Changes to the boost pressure line by the vehicle manufacturer

BTS reference: T912246 **BTS-Service-Set-Nr:** T981183

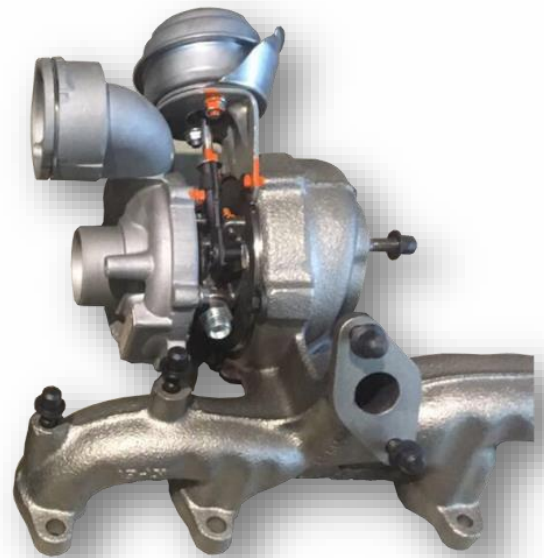
The vehicle manufacturer has made a technical change to the design of the boost pressure line. The turbocharger 038 253 016 D (716213-0001) was replaced by the 038 253 016 G (721021-0004)

If the older version of the turbocharger has been installed in your vehicle, the modified charge hose 1J0 145 822 E have to be used.
